UNITED STATES DEPARTMENT OF THE INTERIOR BUREAU OF LAND MANAGEMENT

$\tilde{\Omega}$
Sundry Notices and Reports on Wells	OTO THE WAY NO
. Type of Well	5. Lease Number NM 012335 If Indian, All. or 6. Tribe Name
. Name of Operator Phillips Petroleum Company	7. Unit Agreement Name San Juan 30-5 Unit
. Address & Phone No. of Operator	8. Well Name & Number SJ 30-5 Unit #64
5525 Highway 64, NBU 3004, Farmington, NM 87401 505-599-343	5 9. API Well No. 30-039-21792
. Location of Well, Footage, Sec., T, R, M	10. Field and Pool
Sec., TN, RW, NMPM	Gol) Blanco Pictured Cliff
1450' FSL & 1630 FEL	11. County and State
√ Section 31, T-30-N, R-5-W	Rio Arriba Co, NM
OTHER PROPERTY NAMED AND ADDRESS OF PARTY PROPERTY.	OTTER DIMI

REVISED PLUG & ABANDONMENT PROCEDURE

San Juan 30-5 Unit #64
Blanco Pictured Cliffs
SE Section 31, T-30-N, R-05-W
Rio Arriba Co., NM

Proposed P&A

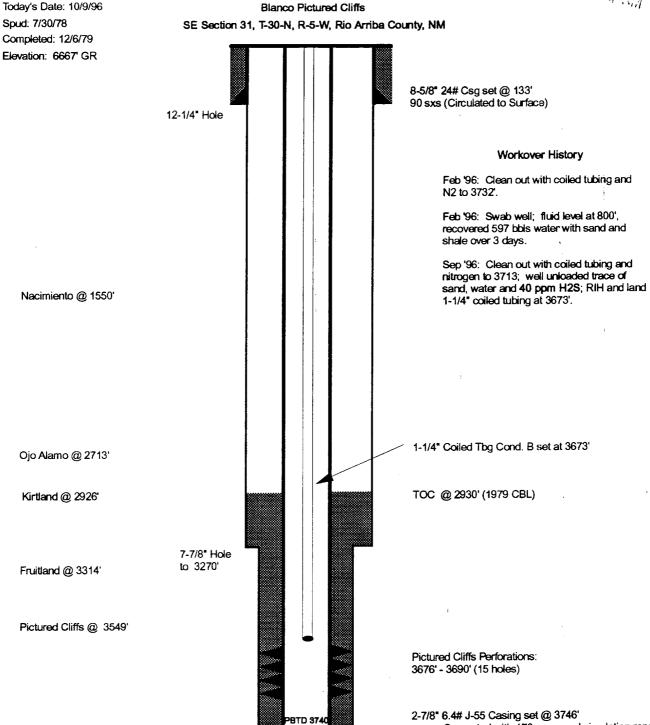
3. Describe Proposed or Completed Operations	
Phillips Petroleum submitted a sundry notice on December 12, 1995 to On January 19, 1996 the BLM amended and approved the plugging p	
On January 19, 1996 the BLM amended and approved the plugging p A recent review of the well file questions the top of cement in the 2-7/8 A Temperature Survey on 8-5-78, indicates TOC at 2275', which is ab	elan. 8" by 7-7/8" annulus. Nove the Ojo Alamo.
On January 19, 1996 the BLM amended and approved the plugging p A recent review of the well file questions the top of cement in the 2-7/8	elan. 8" by 7-7/8" annulus. Nove the Ojo Alamo.
On January 19, 1996 the BLM amended and approved the plugging p A recent review of the well file questions the top of cement in the 2-7/8 A Temperature Survey on 8-5-78, indicates TOC at 2275', which is ab	elan. 8" by 7-7/8" annulus. Hove the Ojo Alamo. How the Kirtland top at 2926'.
On January 19, 1996 the BLM amended and approved the plugging p A recent review of the well file questions the top of cement in the 2-7/8 A Temperature Survey on 8-5-78, indicates TOC at 2275', which is ab A Cement Bond Log on 11-5-79, records a TOC at 2930', which is bel	elan. 8" by 7-7/8" annulus. Hove the Ojo Alamo. How the Kirtland top at 2926'.

On January 19, 1996 the BLM amended and approved the plugging p A recent review of the well file questions the top of cement in the 2-7/8 A Temperature Survey on 8-5-78, indicates TOC at 2275', which is ab A Cement Bond Log on 11-5-79, records a TOC at 2930', which is bel	elan. 8" by 7-7/8" annulus. Hove the Ojo Alamo. How the Kirtland top at 2926'.
On January 19, 1996 the BLM amended and approved the plugging p A recent review of the well file questions the top of cement in the 2-7/8 A Temperature Survey on 8-5-78, indicates TOC at 2275', which is ab A Cement Bond Log on 11-5-79, records a TOC at 2930', which is bel	elan. 8" by 7-7/8" annulus. Hove the Ojo Alamo. How the Kirtland top at 2926'.
On January 19, 1996 the BLM amended and approved the plugging p A recent review of the well file questions the top of cement in the 2-7/8 A Temperature Survey on 8-5-78, indicates TOC at 2275', which is ab A Cement Bond Log on 11-5-79, records a TOC at 2930', which is bel Please amend the plugging plan per the attached procedure and well I hereby certify that the foregoing is true and correct. Title Production Superintender	elan. 8" by 7-7/8" annulus. Bove the Ojo Alamo. Bow the Kirtland top at 2926'. Boore schematics.

On January 19, 1996 the BLM amended and approved the plugging p A recent review of the well file questions the top of cement in the 2-7/8 A Temperature Survey on 8-5-78, indicates TOC at 2275', which is ab A Cement Bond Log on 11-5-79, records a TOC at 2930', which is bel Please amend the plugging plan per the attached procedure and well! I hereby certify that the foregoing is true and correct.	elan. 8" by 7-7/8" annulus. Bove the Ojo Alamo. Bow the Kirtland top at 2926'. Boore schematics.

- 3. Tally 1-1/4" tubing work string. PU and round-trip 2-7/8" wireline gauge ring or casing scraper to 3616'.
- 4. Plug #1 (Pictured Cliffs perforations and Fruitland top, 3616' 3100'): PU 2-7/8" wireline set bridge plug and RIH; set at 3616'. RIH with open ended tubing to 3616'. Load casing with water and pressure test to 500#. Mix 16 sxs Class B cement and spot a balanced plug inside casing above the bridge plug at 3616' to 3100' to cover Ft top. POH with tubing.

- 5. Plug #2 (Kirtland and Ojo Alamo tops, 2920' 2663'): Perforate 4 squeeze holes at 2920'. If casing pressure tested the attempt to establish rate into squeeze holes. If unable to pump into then only set an inside plug. PU 2-7/8" wireline cement retainer and RIH; set retainer at 2713'. RIH with stinger to 2713'. Load casing with water and pressure test casing to 500#. Circulate casing with corrosion inhibited water. Sting into retainer and establish rate into squeeze holes. Mix 136 sxs Class B cement, squeeze 128 sxs outside 2-7/8" casing from 2920' to 2663' and leave 8 sxs cement inside casing over Ojo Alamo top. POH with tubing.

- 6. Plug #3 (Nacimiento top, 1600' 1500'): Perforate 4 squeeze holes at 1150'. PU 2-7/8" wireline cement retainer and RIH; set at 1550'. RIH with stinger and pressure test casing to 500#. Sting into retainer. Establish rate into squeeze holes. Mix 54 sxs Class B cement, squeeze 50 sxs outside 2-7/8" casing from 1600' to 1500' and leave 4 sxs cement inside casing over Nacimiento top. POH and LD tubing and setting tool.

- 7. Plug #7 (Surface): Perforate 4 squeeze holes at 183'. Establish circulation out bradenhead valve. Mix approximately 80 sxs Class B cement and pump down 2-7/8" casing, circulate good cement out bradenhead valve. Shut in well and WOC.
